OSSF Inspection Sheet

Permit of Authorization to Construct an On-Site Sewage Facility Permit Valid For One Year From Date Issued

Permit Number: 118124
Issued This Date: 12/27/2024
This permit is hereby given to: Kacey McQuiston and Karen Caga

RE: 876 Indigo Run - Water line variance request

KACEY MCQUISTON AND KAREN CAGA
876 INDIGO RUN
BULVERDE, TX 78163
COMAL TRACE UNIT 5
LOT 143
COMAL COUNTY

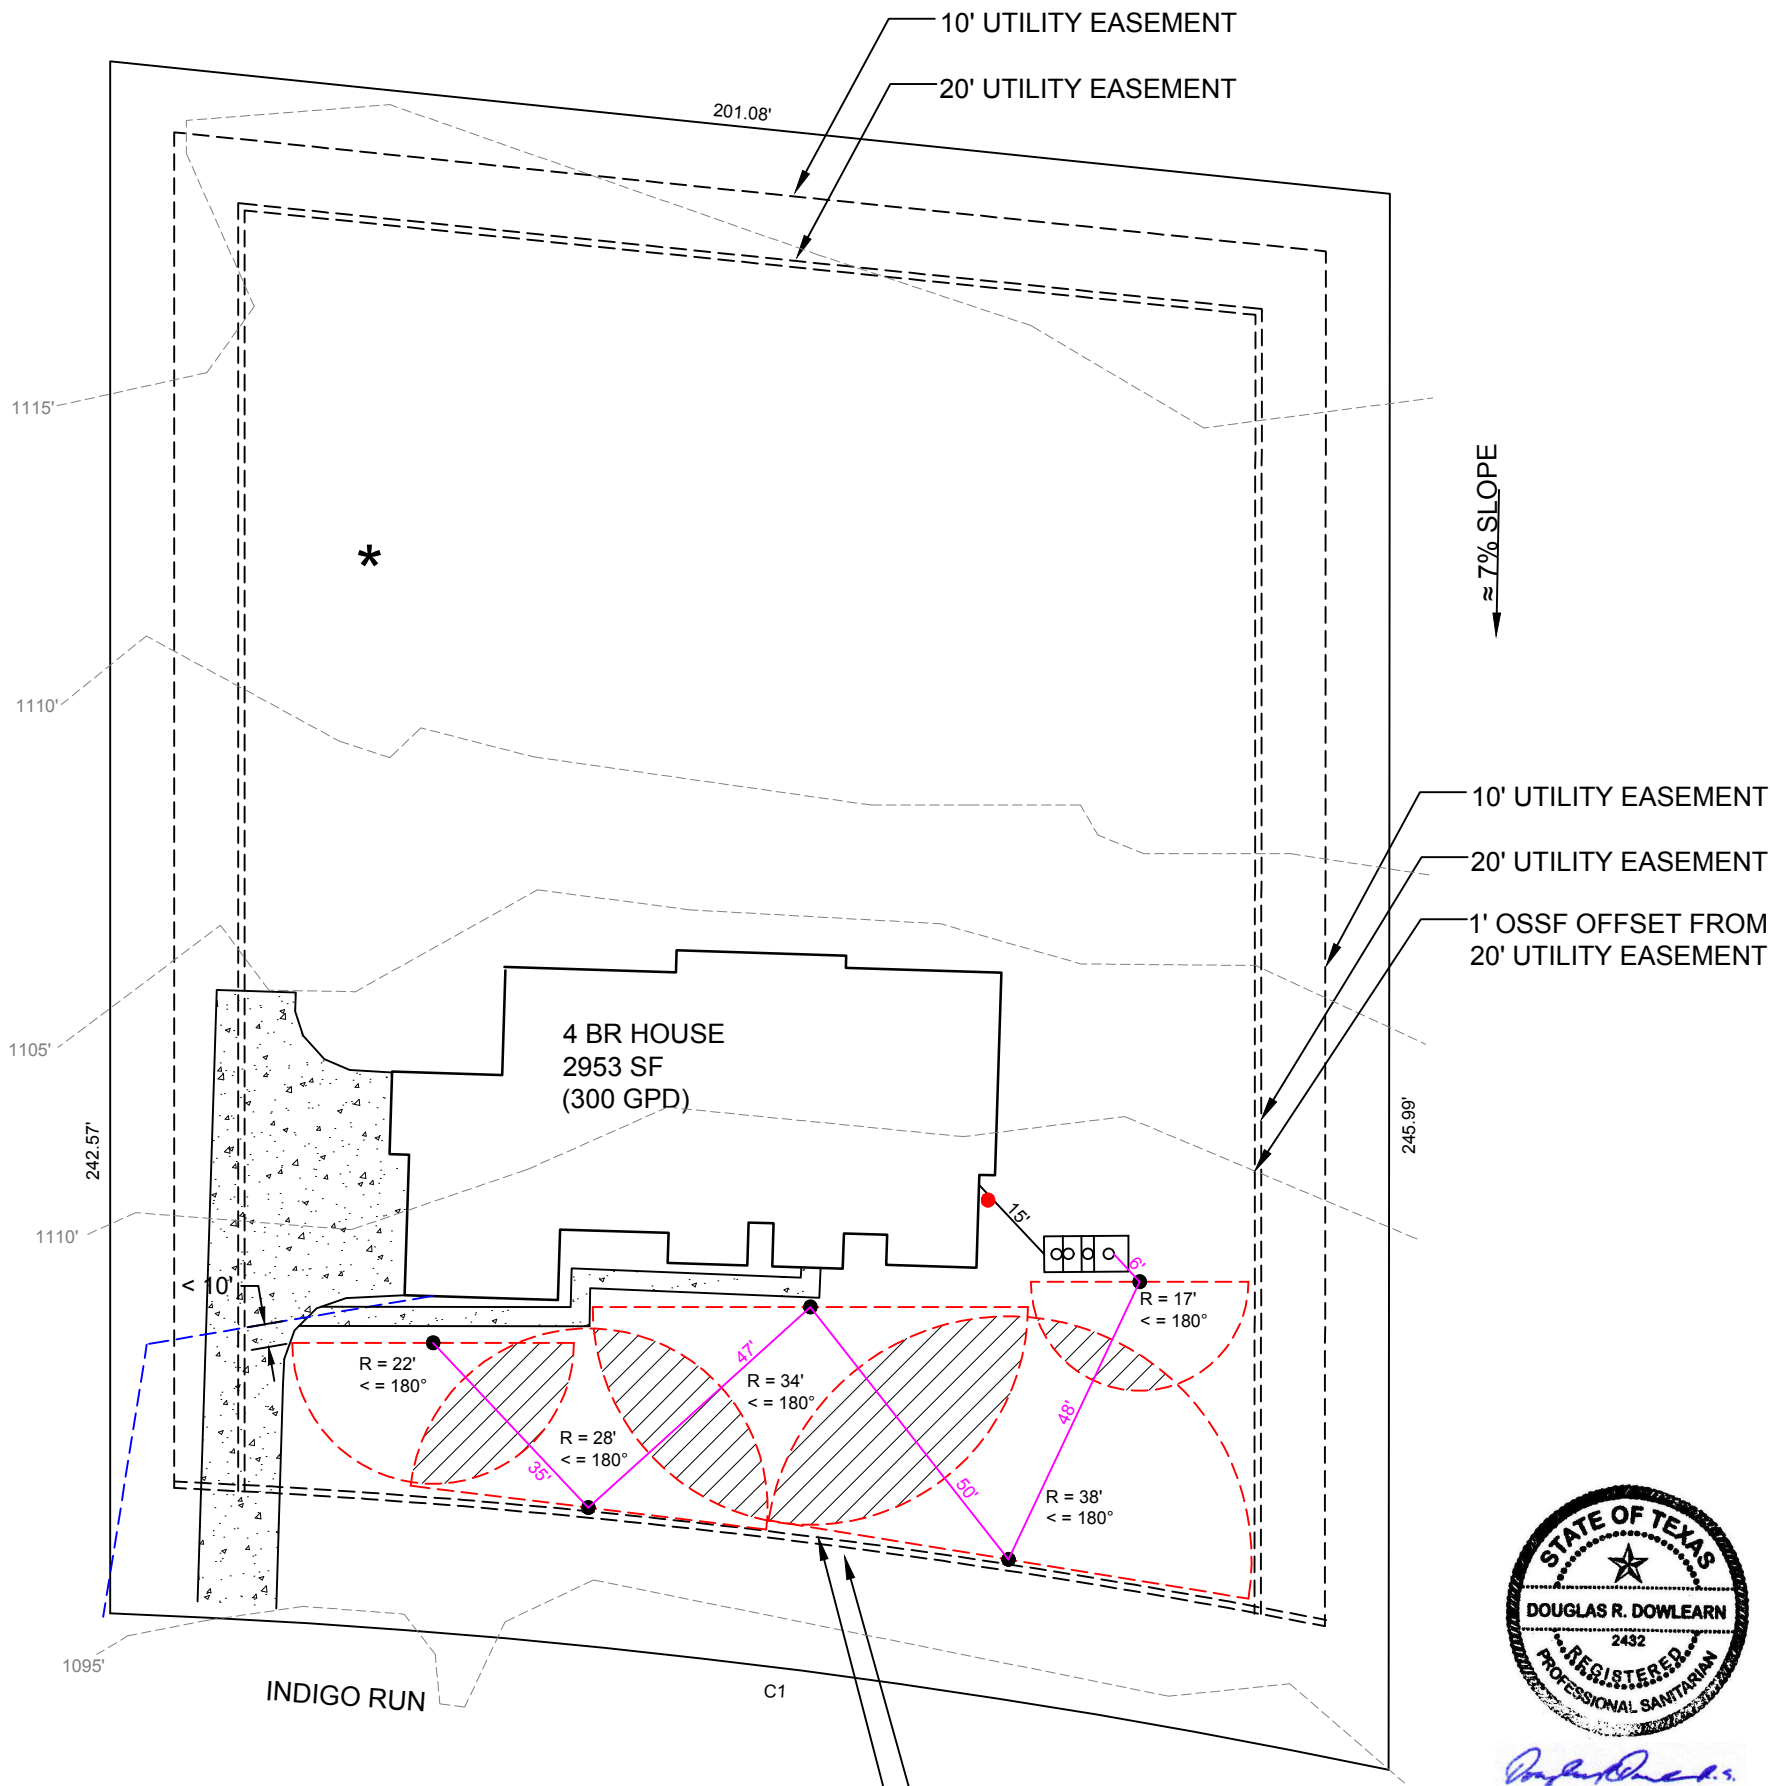
File has been updated. Does the sleeving mentioned in the variance request comply with TAC 290 Public drinking water?

I am requesting a variance for a water line to be placed within 10 feet of a spray application area in the following manner which provides equivalent protection to the requirements of Comal County OSSF rules. This variance is requested due to limited space. Equivalent protection will be maintained by sleeving the water line with SCH 40 PVC pipe where it is within 10' of the spray application area. In my professional opinion this variance will not pose a threat to the environment or public health.

- 1" SCH 40 PURPLE PIPE TO ALL SPRAY HEADS.
- 1" SCH 40 PURPLE PIPE WILL BE SLEEVED IN SCH 40 PVC PIPE WHERE IT IS WITHIN 5' OF OR CROSSES UNDER SURFACE IMPROVEMENTS, DRIVE, WALKWAYS AND 5' BEYOND. THIS WILL PROVIDE EQUIVALENT PROTECTION FOR THE OSSF SETBACK REQUIREMENTS OF TAC 285.

- WATER LINE SHALL BE SLEEVED WHERE IT IS WITHIN 10' OF THE SPRAY AREA. SLEEVED THE WATER LINE WILL PROVIDE EQUIVALENT PROTECTION TO COMAL COUNTY OSSF RULES.
